City of Broken Arrow

Drainage Advisory Committee

PROJECT REPORT

Subject: Liberty Trail retaining wall evaluation – Broken Arrow, OK

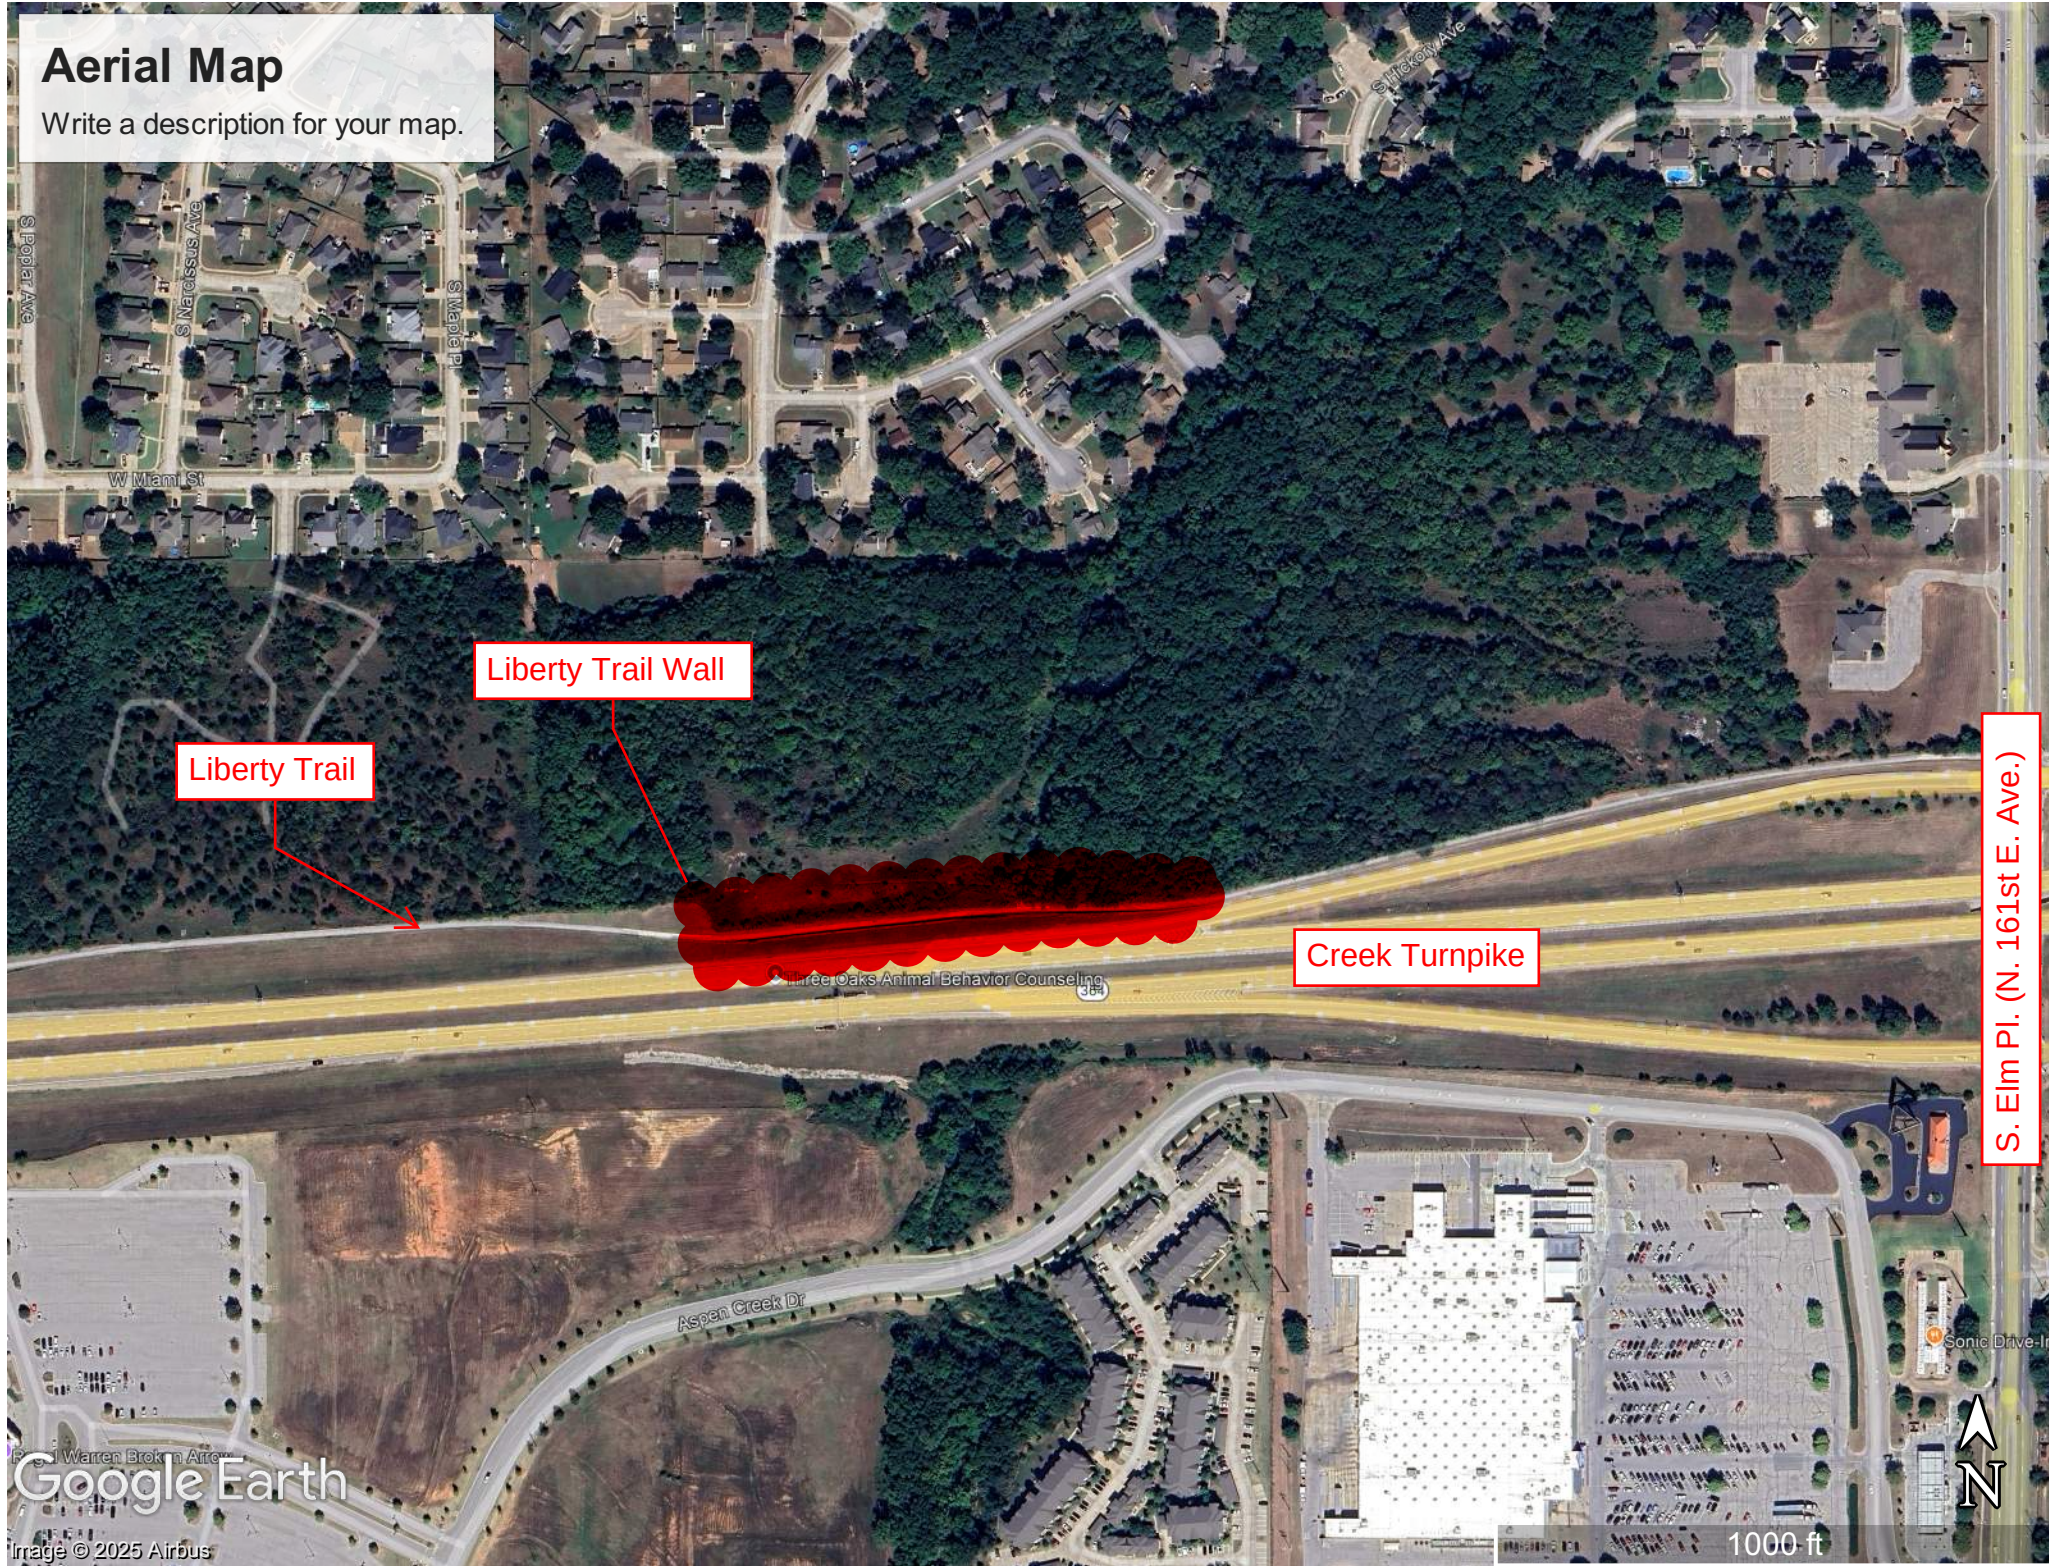
NO SWALE ATOP
WALL TO DIRECT
RUNOFF AROUND
WALL.

SILT FROM RUNOFF
ACCUMULATING
BEHIND BLOCKS.

NO GEOGRID
REINFORCEMENT
VISIBLE.

NO DRAINAGE
GRAVEL BEHIND
BLOCKS.

Figure 1: Bulge in wall

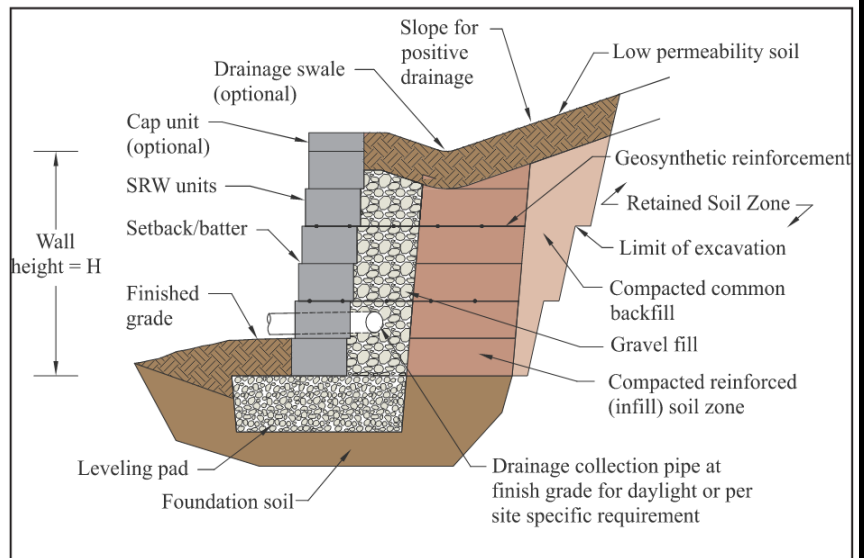
- The wall is located downslope from a highway approximately 35 feet away, with no evident drainage infrastructure to intercept runoff from the road. Surface water appears to be flowing directly toward the wall.
- Sediment accumulation behind the wall, as seen in the bulged section, suggests prolonged water migration and silt deposition are exerting pressure on the wall face (see Figure 1).

- **Demolish and reconstruct** the existing wall using a segmental block retaining wall system that complies with current industry standards and best practices.
- **Reuse existing block units** that remain in good structural condition to reduce material costs.
- **Install a surface drainage swale** along the top of the wall to intercept and redirect stormwater runoff from the turnpike, thereby minimizing water accumulation behind the wall.
